WASATCH COUNTY JSPA PLANNING COMMITTEE MINUTES

OCTOBER 17, 2024

Project: DEV-10154 | Deer Cove Road Plan Preliminary approval and Materials and Design Handbook preliminary review
Meeting Date: 19 August 2025
Report Date: 12 August 2025
Report Author: Doug Smith
Council Action Required: Yes
Type of Action: Legislative
Applicant: Deer Cove Company LLC.

Deer Cove Drive Village Street cross section.

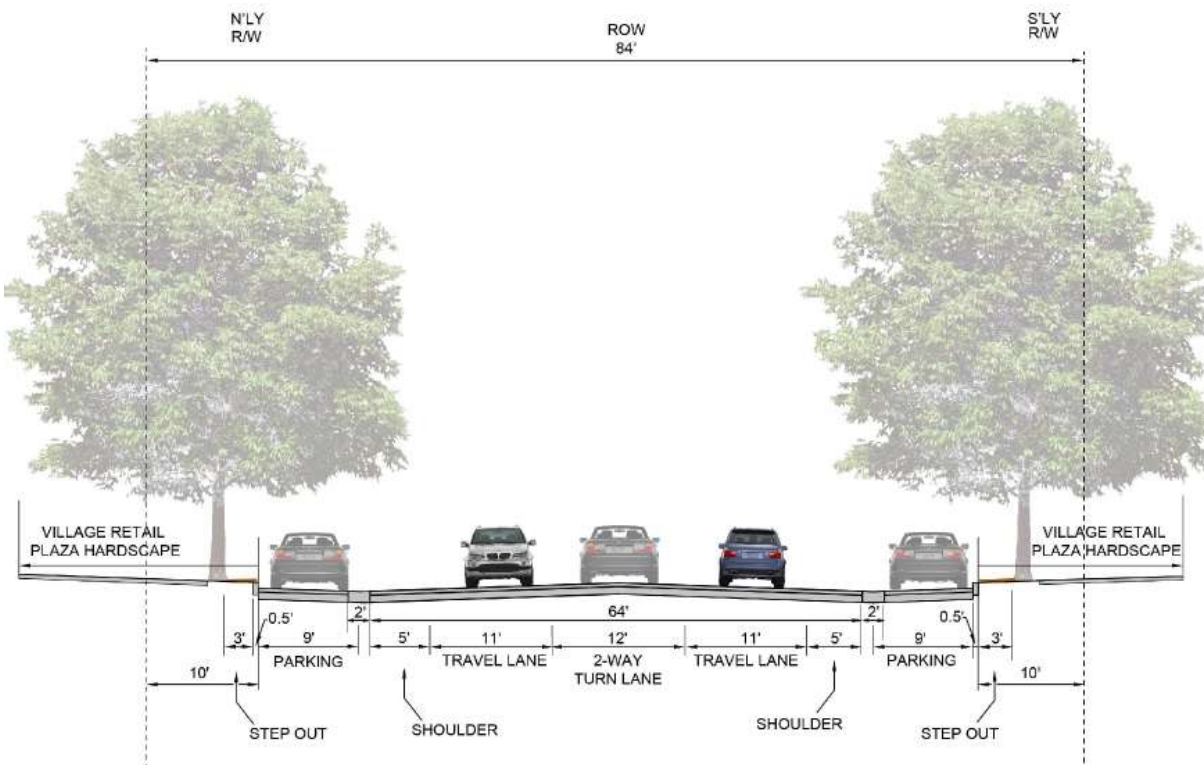
The trees in the village are spaced on Center every 30'. There is high level landscape plan provided. The roadway plat drawings show trees on the various roads and their spacing and has several options for species type. The spacing of trees is formal in the denser portions of the development and become clustered in the less dense portions of the development. Sizes are not noted.

The existing design handbook does not have details for urban projects and formal more regimented street tree plantings. This will need to be provided with the final roadway plat application and approved concurrently.

The final roadway plat drawings will need to specify species, sizes, numbers and irrigation. Trees are required to be at least 2" caliper and 6' tall at time of planting.

Exhibit E – Plan view for streets

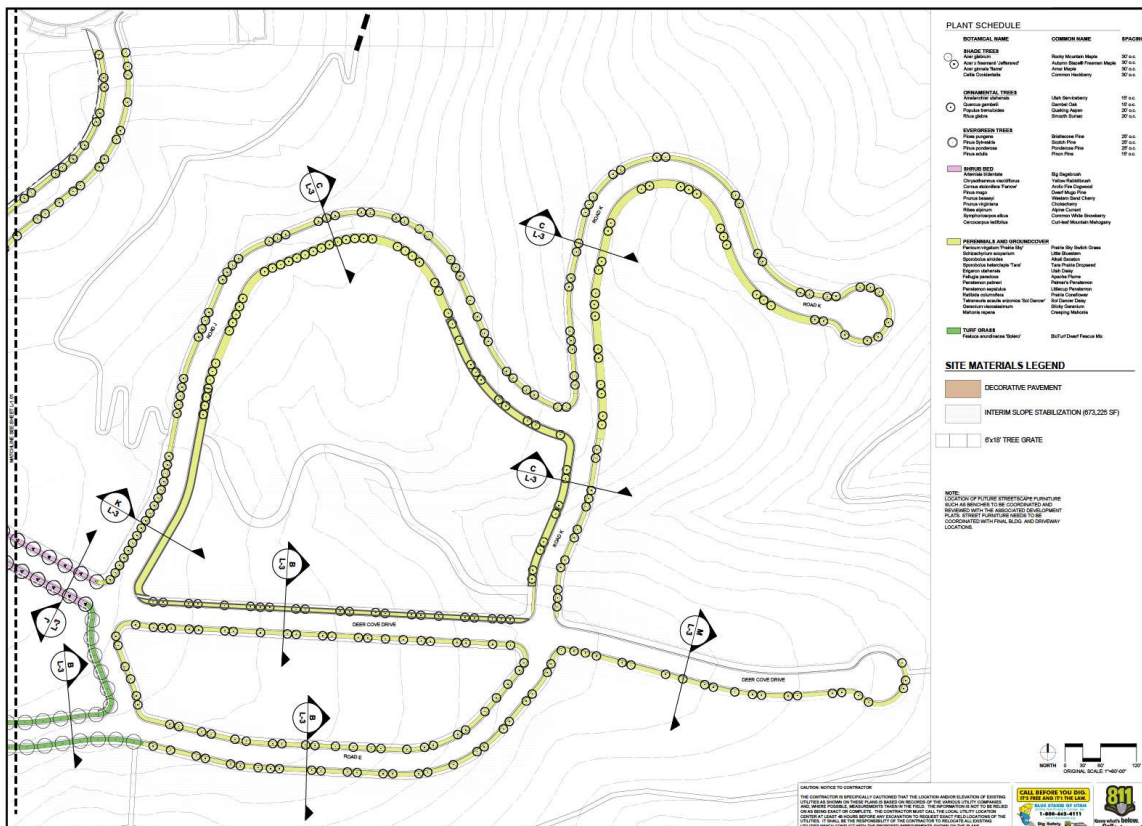
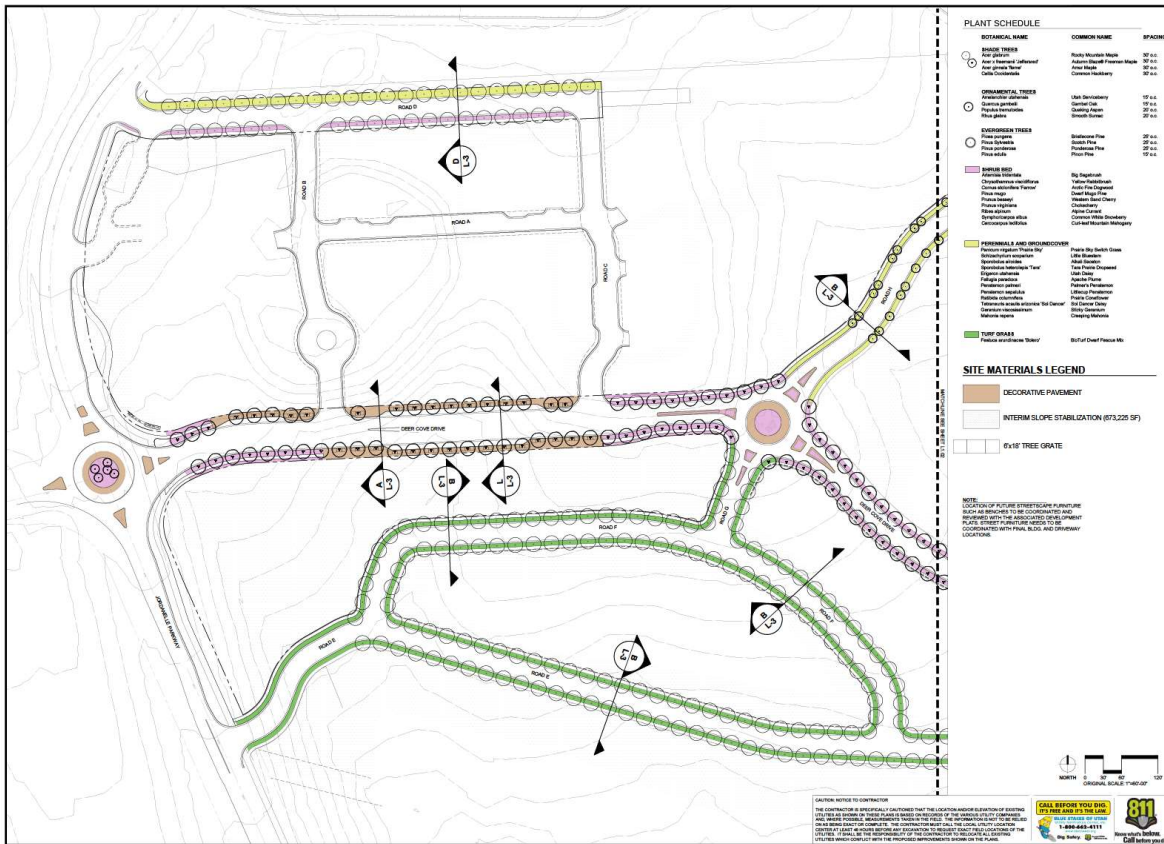
DRC - GIS Dept		
Comment ID	Sheet Name	Comment
DRC-GIS1	Deer Cove Preliminary Roadway Plat	Conditional approval: Please work with the GIS team (gis@wasatch.utah.gov) to create names for these roads for the final plat. To start, send a CAD file of the roads to the

aforementioned email. We can provide you with a road naming guide. Note that the county does not accept any more road names beginning with "Deer," so "Deer Cove" will not be a usable road name. Final plat with road names should also specify which roads are public and which are private.
--	--	--

Exhibit G – Grading Plan and constraints

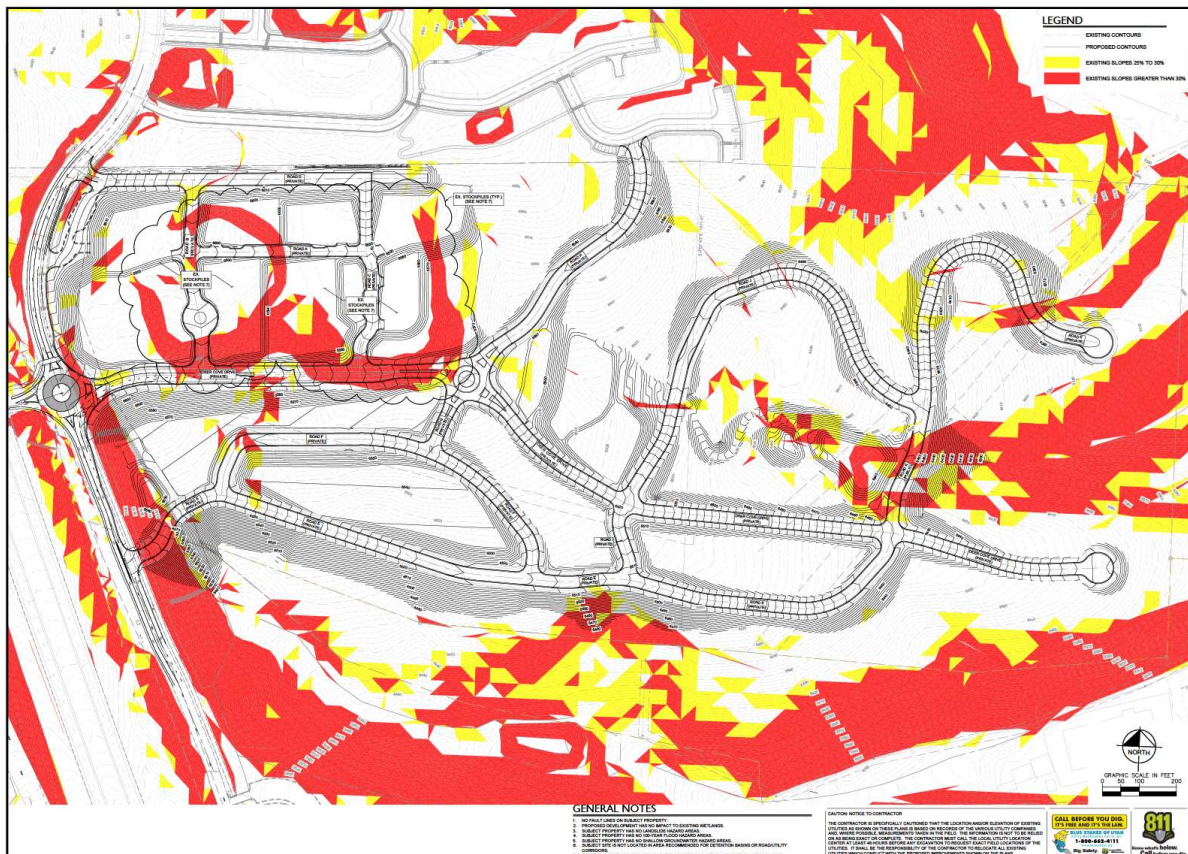
DRC Project Comments		
Comment ID	Entity	Comment
C-PLN-App-13	PLN - County Planning Approval	There is a lot of fill on the site. Building heights in villages can be measured from finished grade but areas outside of a village must be measured from natural grade as per 6.4.3.1. This will need to be resolved at some point. The developer argument is that this is only a roadway plat approval however this sets the alignment for the roads as well as the required fill. The south road creates a lot of fill. Heights for the buildings are measured from natural grade unless this is considered part of a village.
C-PLN-App-14	PLN - County Planning Approval	This comment is from the Engineering Department and is the reason for their rejection: The comments from the 3rd party review by IGES of the AGEC geotechnical report need to be addressed for approval. The comments are uploaded as "Geotechnical Report Response #2".

DRC - Engineering Dept		
Comment ID	Sheet Name	Comment
DRC-ENG36	Geotechnical Report Response #2	Future approvals for site/building permits may require site specific geotechnical studies and slope stability analysis.
DRC-ENG35		Condition of approval: Applicant to have the Geotechnical Report prepared by AGEC updated to address review comments for final. If there are any land drains required for the construction of the roadways as shown on the plat, a map showing the location of the drains needs to be provided
